CITY OF KELOWNA

MEMORANDUM

APPLICATION No.: Z05-0021

PURPOSE: To rezone the subject property from the A1 – Agriculture 1 to the RU1h – Large Lot Housing (Hillside Area) zone, the RU4h - Low Density Cluster Housing (Hillside Area) zone and the P3 – Parks & Open Space zone in order to facilitate a residential subdivision with parks and open space.

CONCEPT PLAN

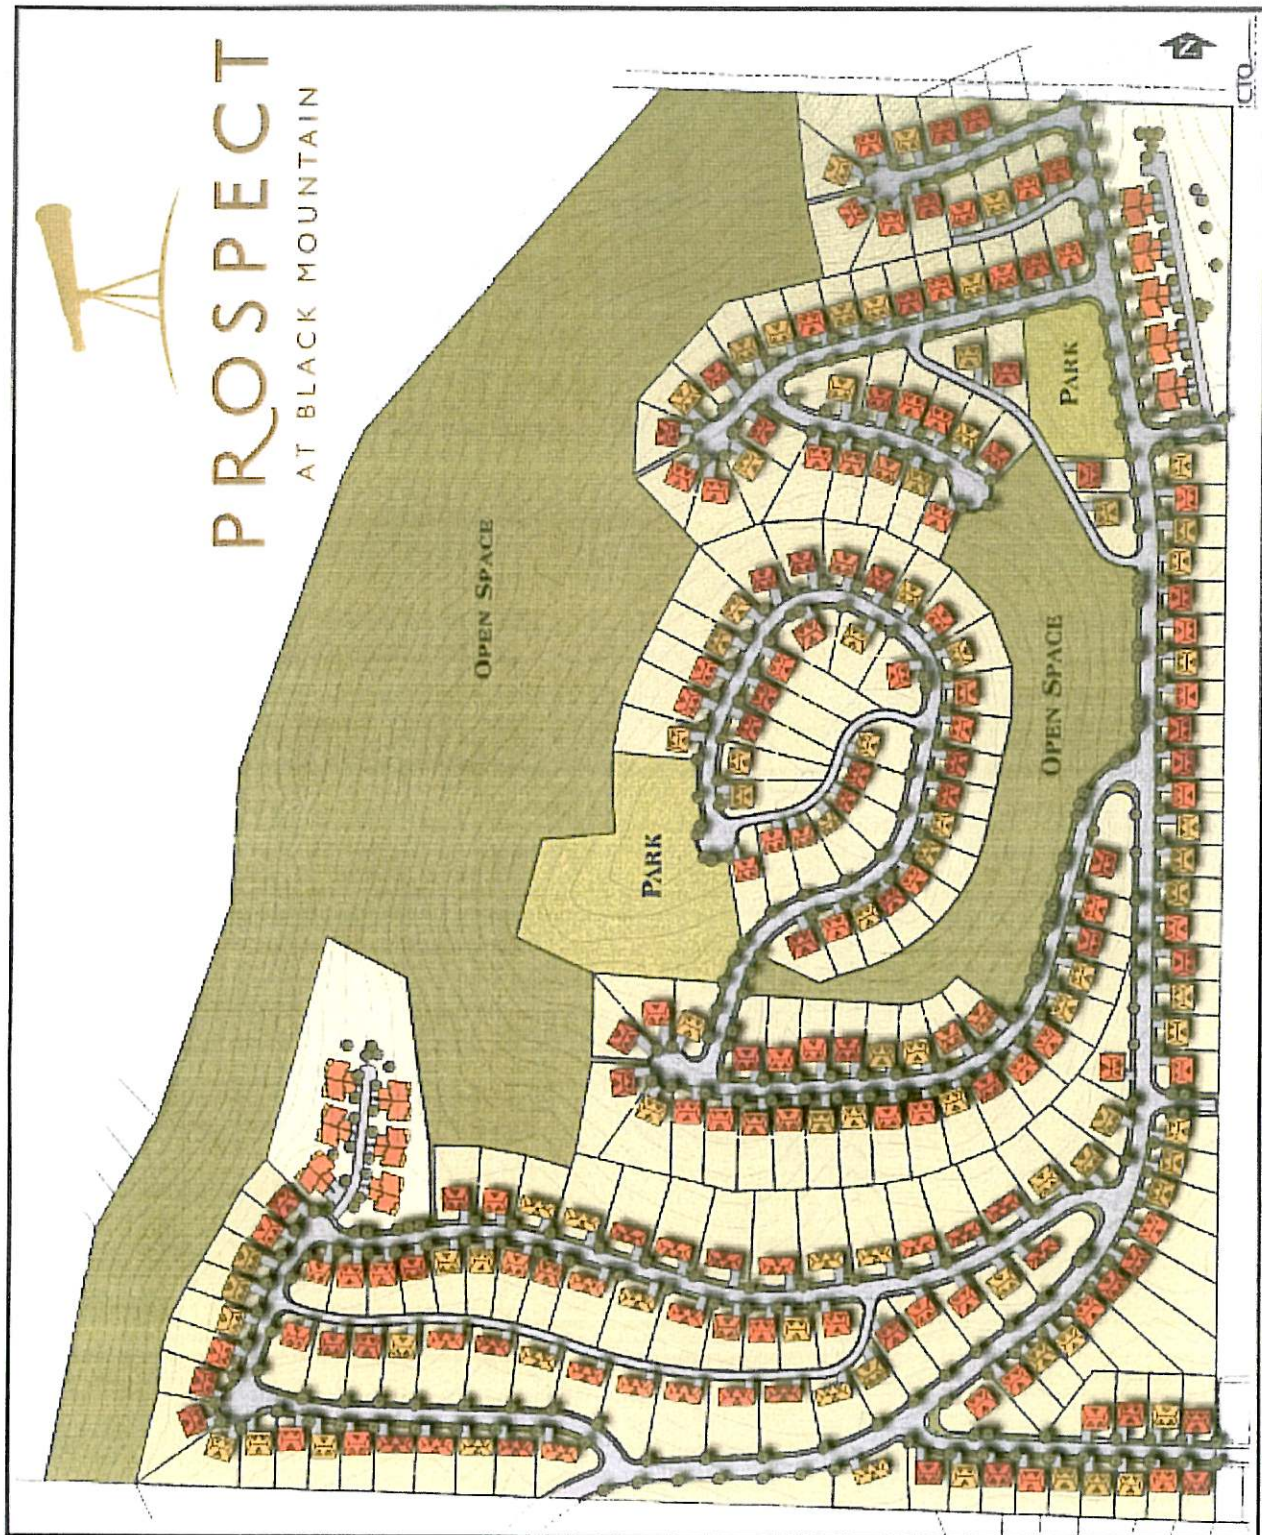
Map Guide indicates that a large proportion of this property consists of slopes exceeding 45%. The preliminary plan shows some effort to avoid steep slopes within the development. The whole site involves slopes of a minimum 15%. Level passenger loading requirements would therefore apply. The layout of the proposed development appears to be unfriendly to pedestrians both due to the steep slopes and the street layout. Connectivity for pedestrians is minimal. The applicant should address these concerns as stated in the Hillside Development Guidelines Section 2.1 Cityscape Principles – Liveability.

1. Preliminary site plan shows home sites on steep sloped areas. Development should not occur on these steep slope areas. It is recommended to retain all steep sloped (30%) areas as natural corridors for habitat and visual quality. Retention of 30% slopes may be considered as off sets to encroachment of Environmental Sensitive Area 2 (refer to Figure 4 in Environmental Assessment Report, August 18, 2005) in other areas of the property.
2. Minimize cut and fill slopes where possible and utilize natural topography in the development design.
3. Minimize the road construction (utilize recommended hillside design guidelines for construction of roads in steep sloped areas).

The older section of Henderson drive was constructed to a standard that is below current local road standards and therefore is not suitable as an alternate access to the proposed development beyond the 14 lots shown on the preliminary layout plan submitted in support of this application.

SLOPE ANALYSIS PLAN (GREATER THAN 30%)

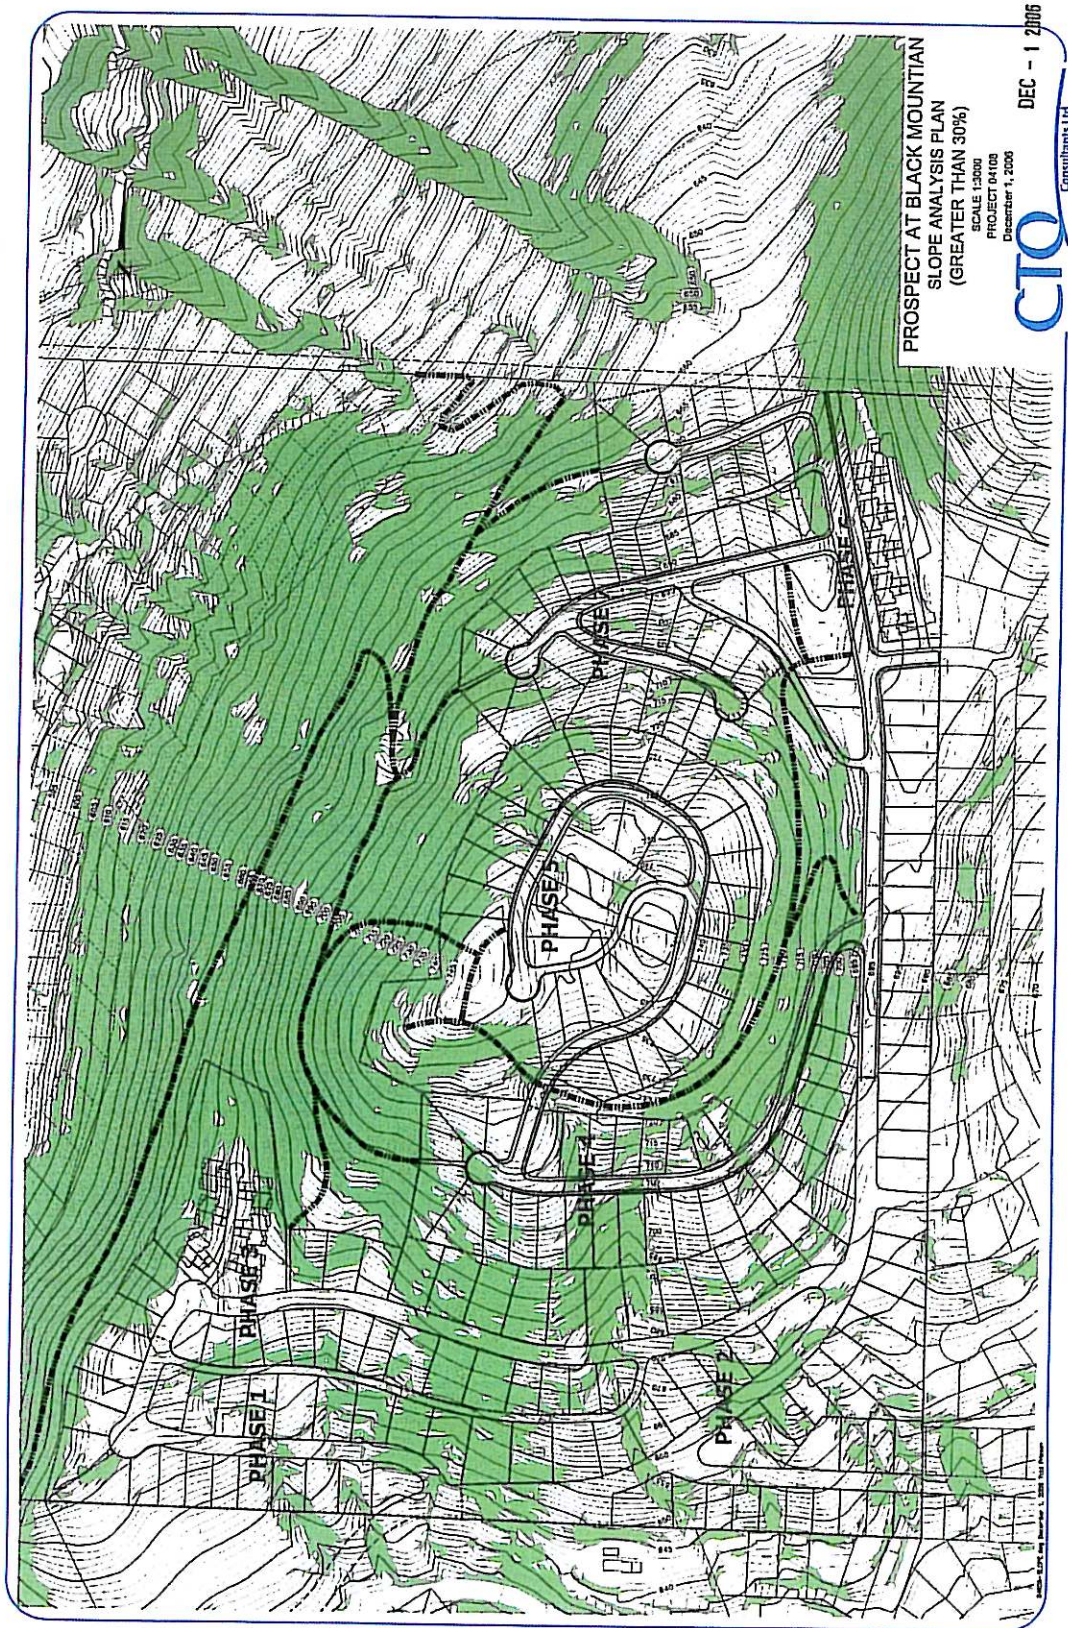
We have no objection to the proposed zoning; provided, the areas proposed for residential land use are on lands with less than 30% slope.

IMPACT ANALYSIS

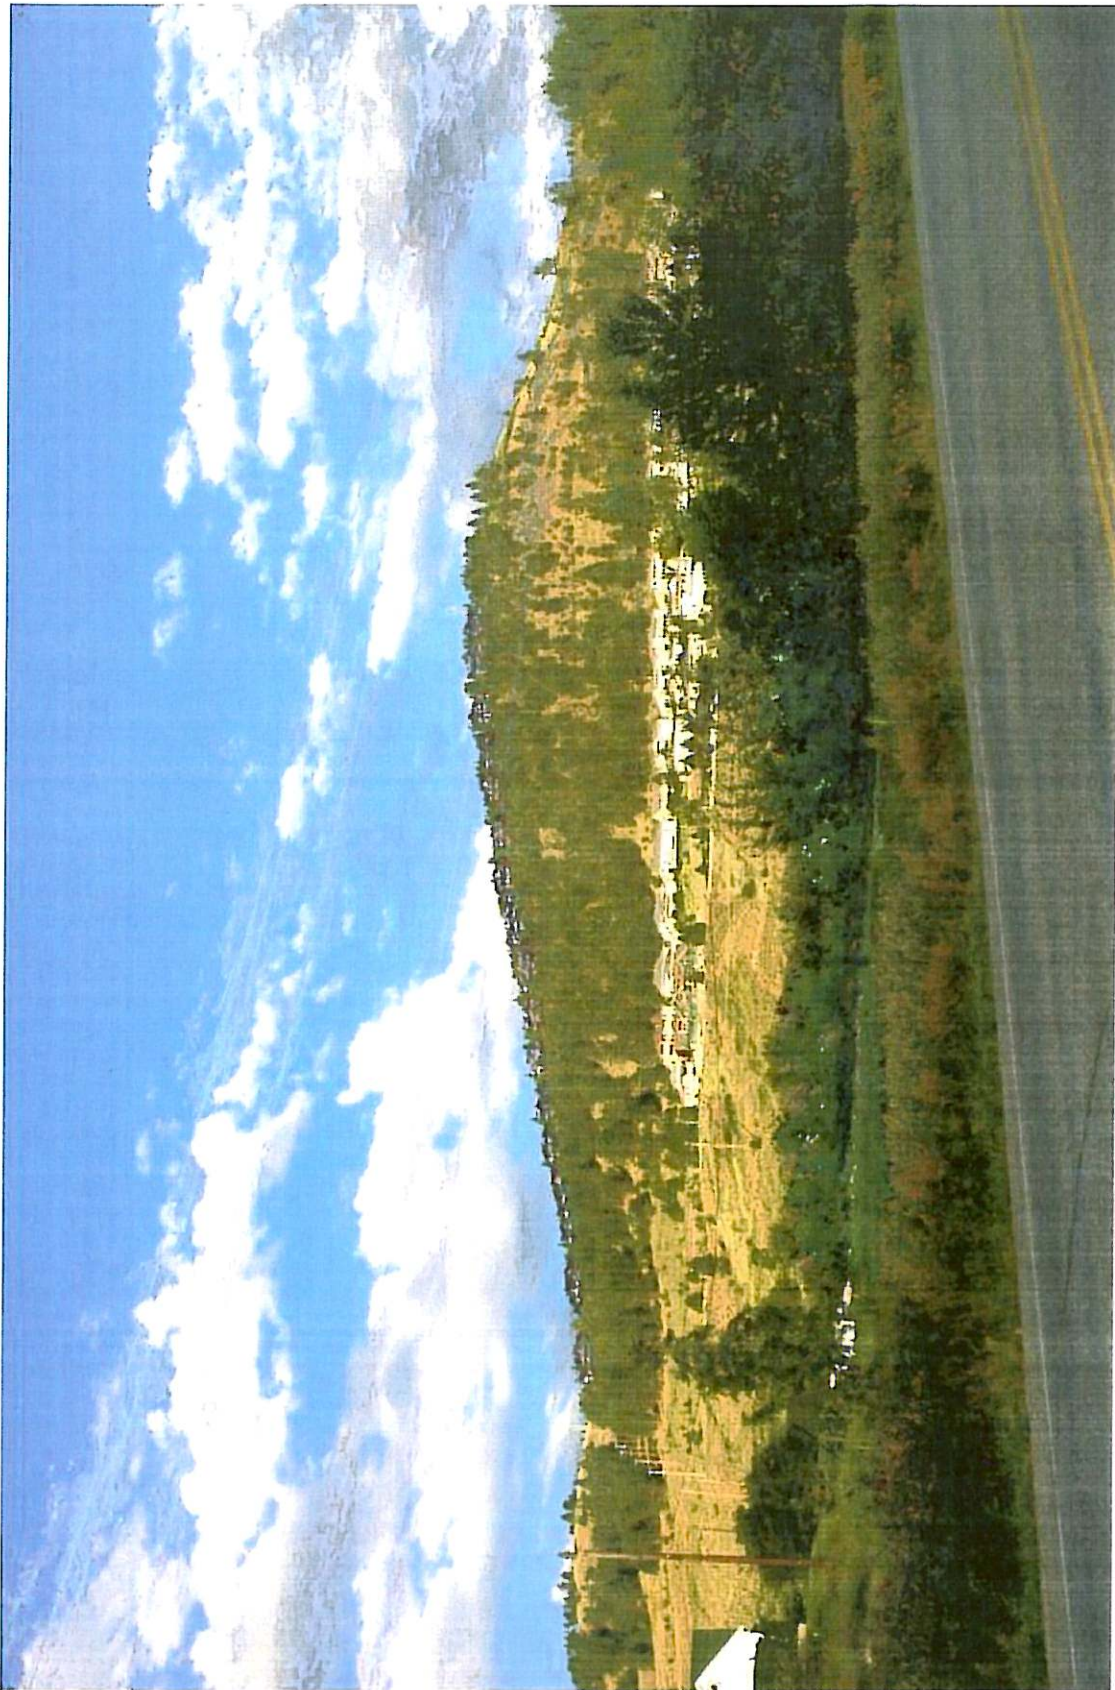
- Section 2.1 *Design Principles - Cityscape Principles* refers to “scenic quality”. In response to expressed concerns about this issue the applicant has prepared and submitted a visual impact assessment image, a copy of which is attached for this report for reference. Recognition of the “natural character of Kelowna’s hillsides are one of the features that make it a unique place to live and visit” the applicant has incorporated provisions in the proposed building scheme to protect the the view from the west of the houses to be constructed along the ridgeline. Views from the hillside are protected for public enjoyment by way of a city-wide park to be located at the top of Mine Hill.
